LINE	QUANTITY	UOP	CAT. NO.	ITEM NUMBER	UNIT PRICE	AMOUNT
				ADDENDUM NO. 2		
				SEE ATTACHED PAGES.		
				END OF ADDENDUM NO. 2		
0001	1	JB	988-15	FENCE, GUARDRAIL AND GATE INSTALLATION		
***** THIS IS THE END OF RFQ DEFK13016 ***** TOTAL:

SOLICITATION NUMBER: DEFK13016
Addendum Number: 2

DEFK13016 Glen Jean AFRC Fence & Guardrail Project

Addendum No. 2

Glen Jean Armory Site Plan

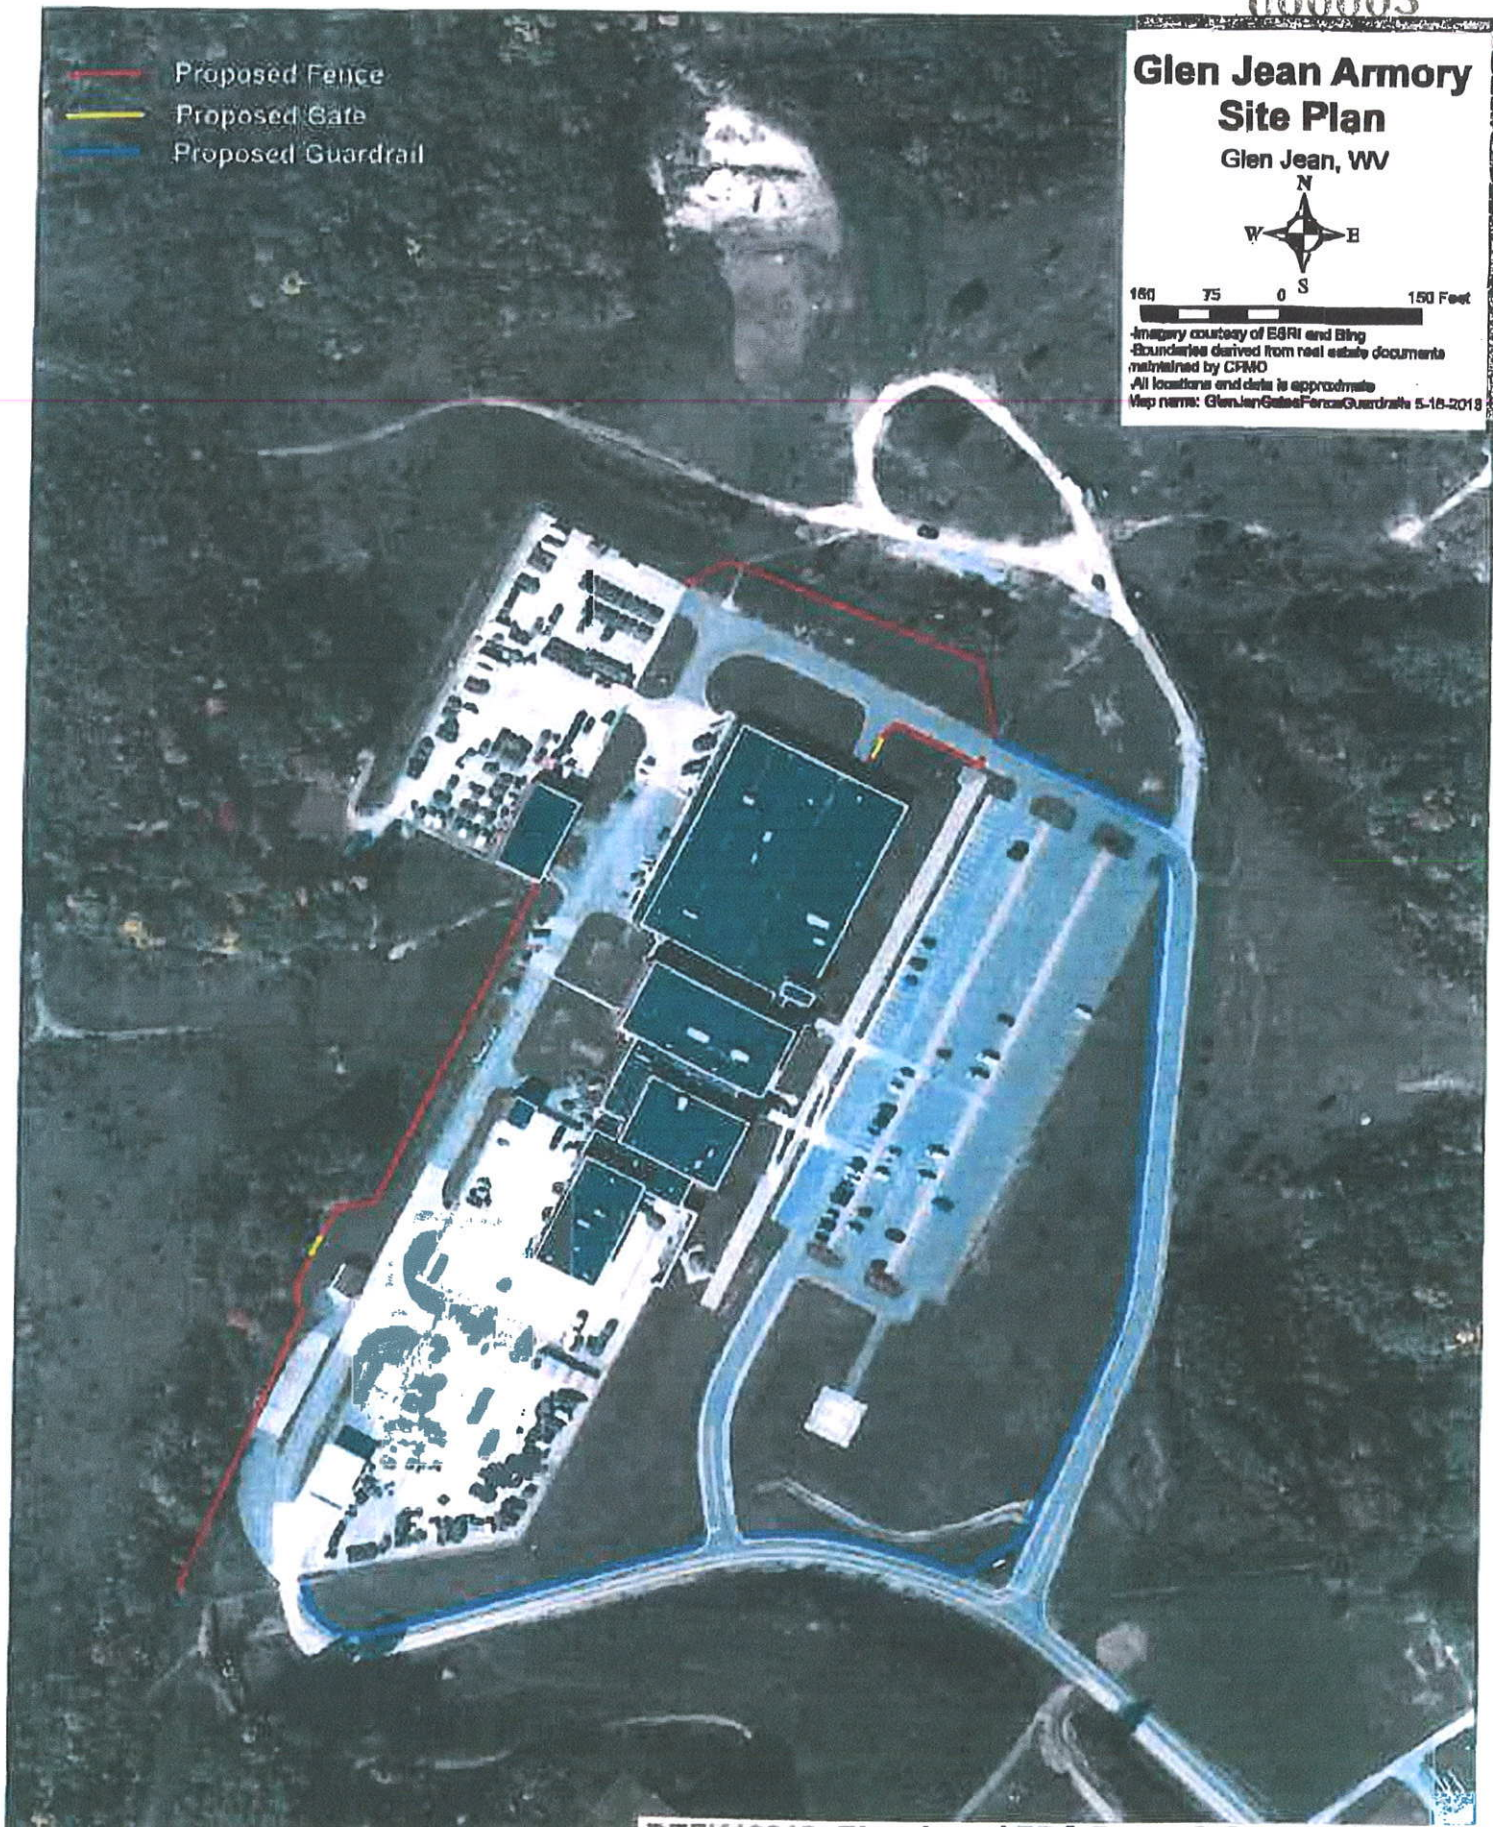
Q1: Please verify the west side fence is to be extended south until it intersects the fence on the south end.

Q2: Please verify that an additional gate is to be installed as discussed at the pre-bid and it is to meet the same specifications as described in the RFQ.

Q3: Please verify the addendum will include the location of the additional fencing and gate on the west side of the property.

A1: True, as discussed at the pre-bid meeting.

A2: True, the project now requires (2) 8'-0" wide gates as stated in the revised summary of work.

A3: Please see the attached revise site plan.
